Re: Lookout Lot 5 (PTS 482904)

By this letter on behalf of my client, Susie McKean who resides at 7809 Lookout Drive (which abuts Lookout Lot 5 to the northwest), we are notifying the La Jolla Shores Planned District Advisory Board that the referenced project, which we understand will be considered by your Board at its meeting on April 21, 2021, is inconsistent in several significant respects with provisions of the La Jolla Shores Planned District Ordinance ("LSPDO") and with policies of the La Jolla Community Plan ("LCP"), as set forth below.

SITE PLAN
LISAB Meeting
SCALE: 1/8" = 1'-0"

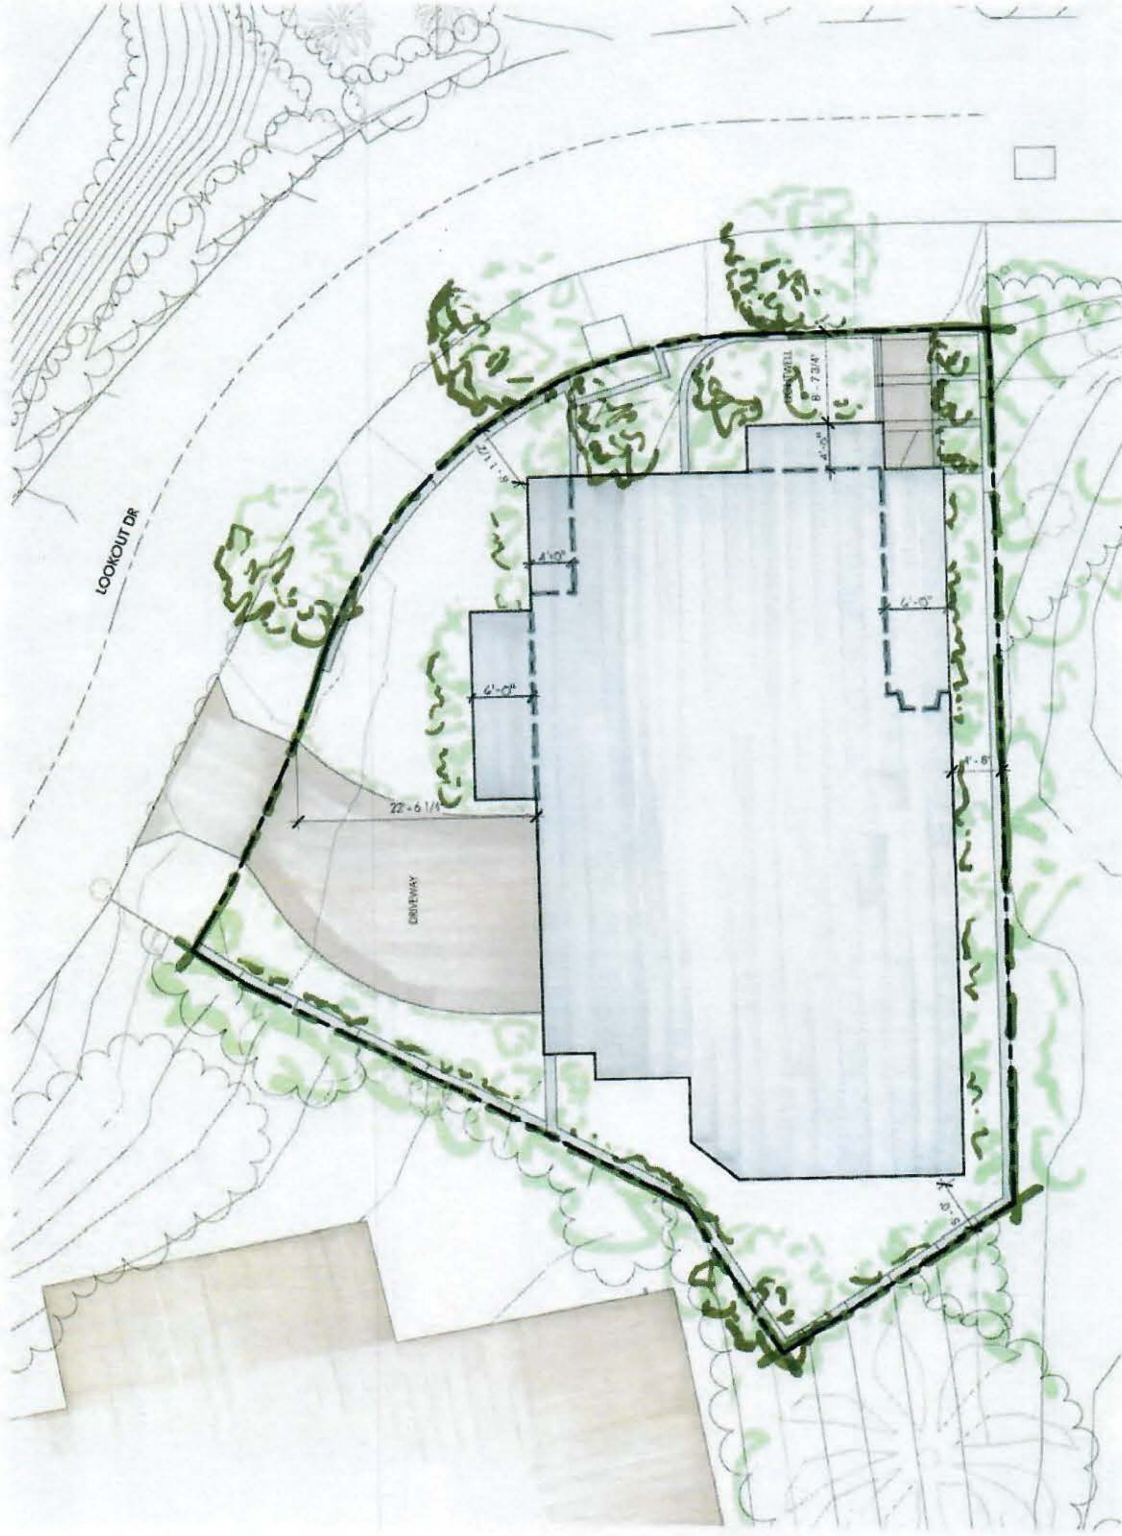
Here, the proposed structures on Lookout Lot 5 would be separated by a claimed distance of four feet, eight inches, barely exceeding the required minimum setback of four feet, from the rear property line of Lookout Lot 5, which abuts Ms. McKean's southern property line. It is apparent from reviewing the applicant's neighborhood survey that Ms. McKean's single-family residence was constructed in close proximity to its southern property line. (See Exhibit A (Ms. McKean's property is identified as Number 32 (with Lookout Lot 5 identified as Lot 38).) In fact, it is the master bedroom of Ms. McKean's home that is located closest to the southern property line abutting Lot 5.

The four-foot, eight-inch separation of the structure proposed on Lookout Lot 5 from Ms. McKean's side property line abutting her bedroom is much lower than the average setback from the side property line in the neighborhood survey prepared by the applicant. The applicant's latest neighborhood survey shows that the average side yard setbacks are six feet, seven inches to six feet, ten inches. It should be noted, however, that the applicant's calculated side yard setbacks improperly included the minimal setbacks of proposed development for Lookout Lots 2 and 5, and excluded the much larger side yard setback of the developed lot at 7716 Lookout Drive. See Exh. A. If the side yard setbacks for proposed Lookout Lots 2 and 5 were excluded from the applicant's calculation, as they should have been, and the side yard setbacks for the developed lot at 7716 Lookout Drive were included, as they should have been, the average side yard setbacks in the neighborhood survey would be considerably higher than six feet, seven inches, to six feet, ten inches. Even with the applicant's errors in calculating average side yard setbacks within 300 feet, which errors result in an understatement of actual average side yard setbacks in the neighborhood, the applicant's calculated average side yard setback is far above the four-foot, eight-inch setback from Ms. McKean's yard by almost two feet (23 inches), or **41 percent**. Accordingly, the proposed development of Lot 5 is not in general conformity with the building setbacks in the vicinity and thus violates SDMC section 1501.0304(b)(4).
